Advisory Wire

REFERENCE NO:	AW700-27-0631, Rev 2	INFORMATION TYPE:	Maintenance Operational
ATA:	27-51	EFFECTIVITY:	Global Express / XRS (9002 - 9312, 9314 - 9380, 9384 - 9425) Global 5000 (9127 - 9383, 9389 - 9400, 9404 - 9431 and 9998) Global 5000 feat. Vision Flight Deck (9386, 9401, 9445 - 9862, and 9868 - 9997) Global 6000 (9313, 9381, 9432 to 9860, 9863 - 9871, 9873 - 9997 and 60005 - 61999) Global 5500, Global 6500 (9861, 9872, 60001 - 61999)
SUBJECT:	Slat/Flap HALFSPEED Messages - Intermittent Slat/Flap Resolver

Figure 1
Right Flap Actuator and Resolver

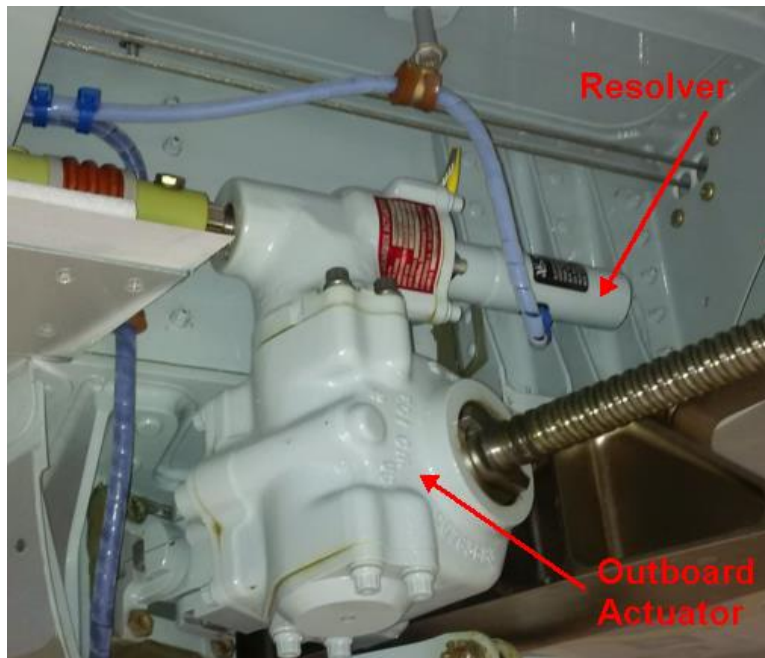
Bombardier has identified a common failure mode in the slat and flap resolvers. The resolver part number GT415-5300-3 rotor winding can break causing the wiring resistance to vary intermittently or become open with the temperature variation. This change in the resistance affects the surfaces position values reported to the SFCUs. When the difference between the left and right resolver value becomes too high, the SFCU connected to this channel will stop operating until the surfaces position values returns within acceptable limits. Since only one of the two channels of the resolver rotor is usually affected, the system continues its operation in degraded mode.

A new Slat Flap Resolver part number 5917991 / GT415-5300-5 is now available and introduces improvements in the rotor core design, reducing the number of wires in the winding and increases the wire gauge.

Both Resolver part numbers (-3 and -5) are interchangeable and intermixable, but a -3 cannot be modified to the latest configuration. Therefore, the -5 version of the Slat and Flap Resolver is available to Operators via the Aircraft Illustrated Parts Catalog (AIPC) on attrition basis, upon failure of a -3 resolver.

- If CAIMS/OMS reports a defective resolver, troubleshooting according to the related fault should be performed according to SmartFix™ Plus (Ref 1.2). In most of these cases the resolver needs to be replaced.
- If no resolver related faults are shown, refer to the applicable EICAS message in the troubleshooting section of the SmartFix™ Plus (Ref 1.2).
